New Jersey Institute of Technology  
323 Dr. Martin Luther King Jr. Blvd  
Newark, NJ 07102-1982  
973.596.3070  
973.596 6085 fax  
Office of Procurement Services

**Date: July 20, 2021**

**Addendum #1**

**RFB 21-14 Micro Phase II and III and Venturelink**

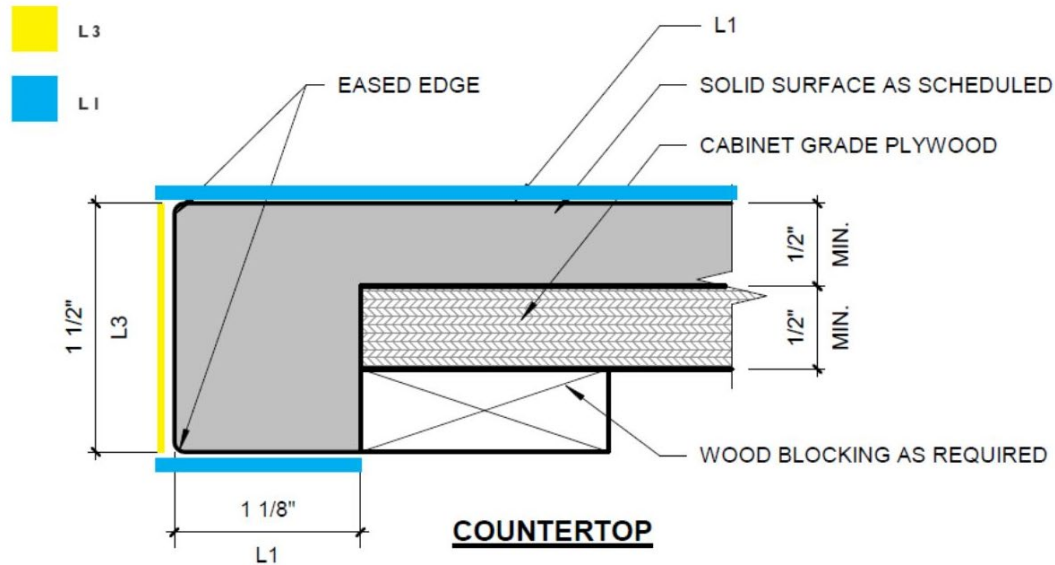
Scope: Casework at Translation Lab

On A9.20/3, there is a solid surface section. Where does this occur?

The Formica locations are described in the interior finish material scheduled and are called out on the millwork drawings. But to clarify, I have listed each below.

L1 – Color core is for countertop surface (horizontal surface) only ( see image ). This is used in case the counter gets damaged by someone in the Lab. The color will show continuous all the way through, and you will not see the brown.

L2 – is for all exterior vertical surfaces within the lab area (except for the countertop edge, highlighted in yellow)

L3 – is for the countertop edge only in the lab areas. Not the conference room.

L4- will be used for the conference room bench and cabinet only. It will not be used in the Lab.

L5 – All interior draws/cabinets will have a red interior accent. No red on the exterior millwork.

General NOTE: All lab millwork will be white outside with a red interior accent and the plywood Formica on the countertop surface edge. The conference room will have a wood look on the outside with a red interior. Refer to A9.20 Elevations for additional information.

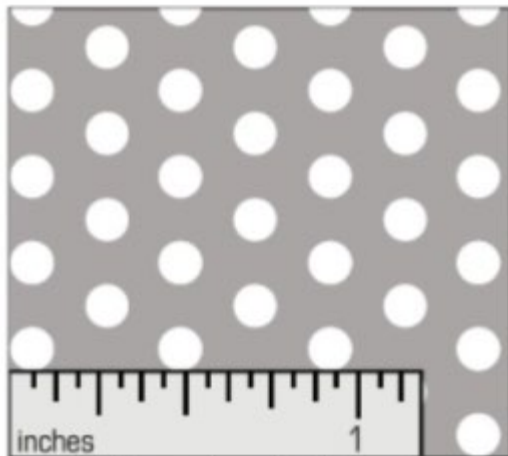
The McNichols vent indicated in the wall cabinet in conference rom 401 detail 14/A9.20 does not have a specification aside from its dimensions. What material, gauge and wire opening size are to be used?

MP1	PERFORATED METAL	McNichols Metal		Round/ Size TBD/ U edge Frame	Electrostatically Painted Black	bulletin board location
				Material: Painted Carbon Steel – Black – Electrostatically painted	Color: Black	Vent for CPU within closet
						MUST MEET CAL 117

Material: Painted Carbon Steel – Black – Electrostatically painted

Hole Pattern: Staggered center / perforated metal / round

Hole Size: 1/8” round on 1/4” stag. Ctrs 1/8” bar, 18.74 HPSI, 23% OA

Margins & End Pattern: holes sheared through. U-edge frame

Gauge: 16
